PARTS & SERVICE NEWS

REF NO. AA01169A

- SUBJECT:** BRAKE CHAMBER OVER-STROKING DURING INITIAL BRAKE APPLICATION AFTER A COLD START
- PURPOSE:** To introduce to the field Rear Brake Pressure Converter Kit (AK4745) for modification of original brake chamber configuration.
- APPLICATION:** Komatsu Dump Trucks: 330M A10190 thru A10223, A10225 thru A10227; HD785-5LC A10224, A10228 thru A10270
- FAILURE CODE:** 2E40Z9
- DESCRIPTION:** This bulletin outlines conditions for the occurrence of over-stroking, and options for resolving this problem.

FIGURE 1. BRAKE PISTON POSITIONING

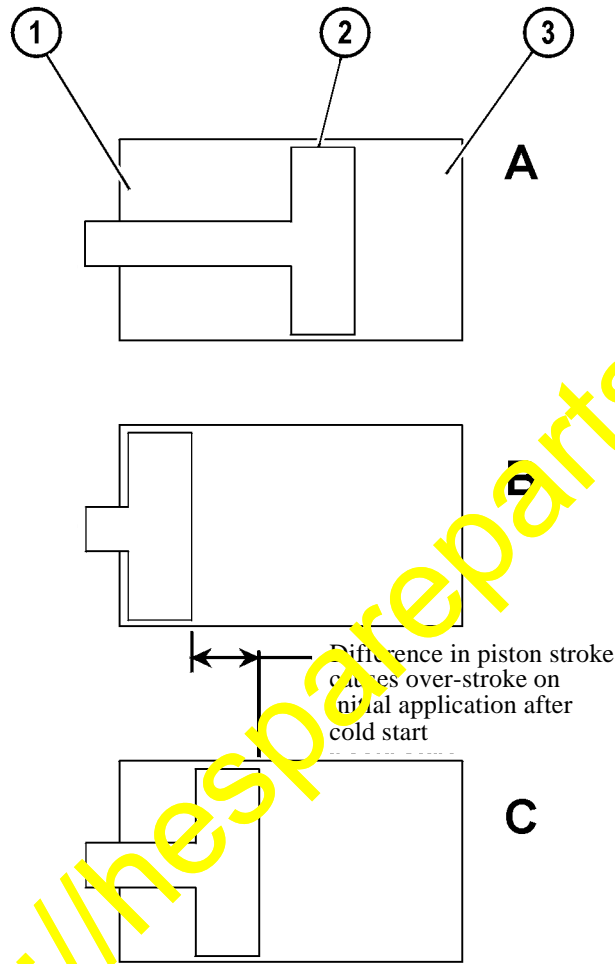
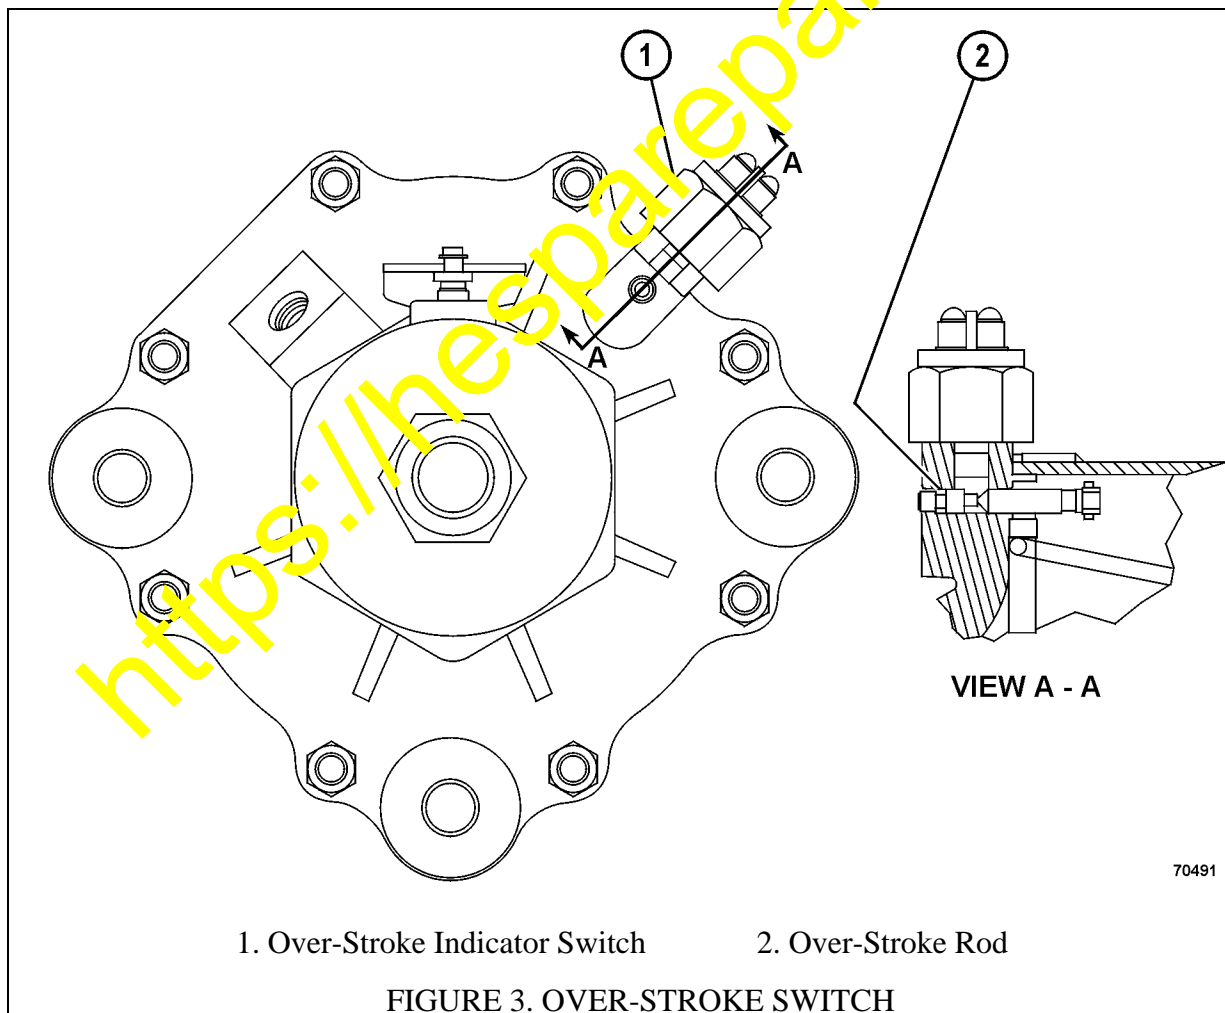
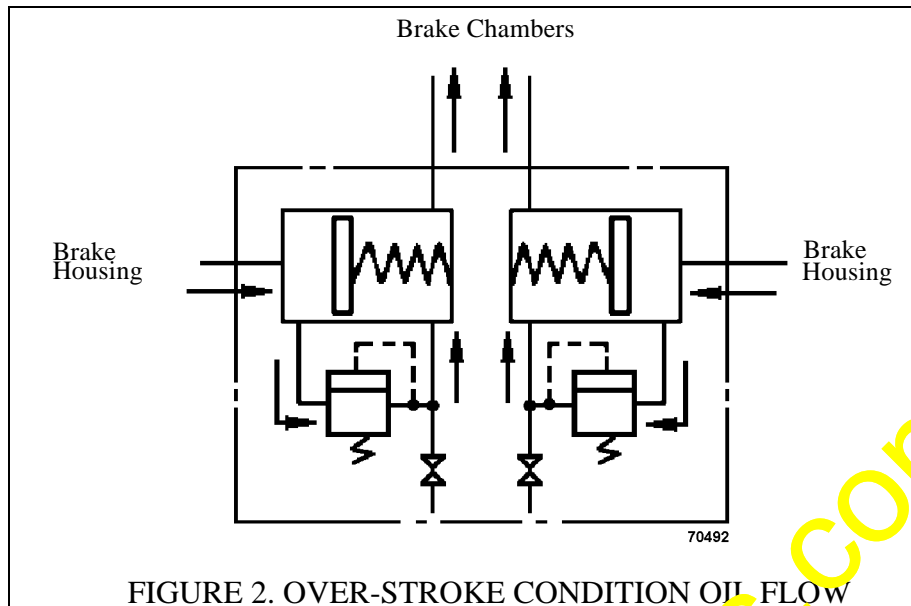
During dormant periods, air pressure in the tanks will gradually be depleted. When the air pressure drops to approximately 3 kg/cm² (45 psi), the rear brakes will apply automatically. This function is a normal safety feature of the truck. After this has occurred, the positioning of the brake piston should be similar to that in view (A, Figure 1).

When the truck is started, the brake cooling oil is pressurized, and the oil pressure in the rear brake housing will return the brake piston to its normal brake "OFF" piston position. Refer to view (C).

At lower temperatures, the cooling oil's increased viscosity will cause higher pressures in the rear axle until the oil has been heated during circulation. During cold start-up, the increased cooling oil pressure will unseat the check valve in the slack adjuster. Refer to Figure 2. This creates a path for oil flow, and enables the brake piston to be pushed away from the friction discs to a position further than its normal position. Refer to view (B, Figure 1). Only at low temperatures does the cooling oil have the viscosity to cause pressures that are able to unseat the check valve.

The first time the rear brakes are activated after start-up, usually by the retarder lever, the rear brakes may experience a temporary loss or reduction in braking effort. This is due to the longer brake piston stroke required to apply the brakes. The oil capacity in the brake chamber is not enough to move the piston through the increased travel that is required to move the brake piston to its normal "APPLY" position, view (A). The rear brake caution lamp in the cab should illuminate after an over-stroke, such as this, occurs. The truck will still have front brakes available as this occurs.

If resetting the rods on the brake chambers is not a desirable solution, rear brake pressure converter kit (AK4746) may be installed to eliminate this problem. Prior to the installation of this kit, carefully check the air and brake circuits for any leaks that may contribute to over-stroking. Potential leak paths include, but are not limited to:
